Proposal #25: 7239-00-70, WISC 2018 024
T Adams, W Kenyon Road
Br Squaw Creek Bridge B270162
Loc Str
Jackson County

This is Addendum No. 01, which provides for the following:

**Addendum No. 01
ID 7239-00-70
Revised Sheet 39
November 20, 2017**

STATE OF WISCONSIN DEPARTMENT OF TRANSPORTATION	
STRUCTURE B-27-162	PLANS EXCD.
GENERAL DETAILS	SHEET 3 OF 17
39

ABUTMENT PLAN WITH WING
(SHOWING STRUCTURE BACKFILL LIMITS)

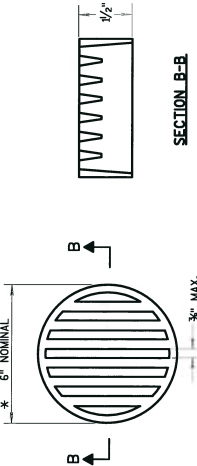
Revised Plan Sheets	
Plan Sheet	Plan Sheet Title (brief description of changes to sheet)
39	General Details, Revised structure backfill detail to show correct wing in plan view

NO.	DATE	REVISION	BY
1	11/20/17	CHANGED WING IN DETAIL	MJB
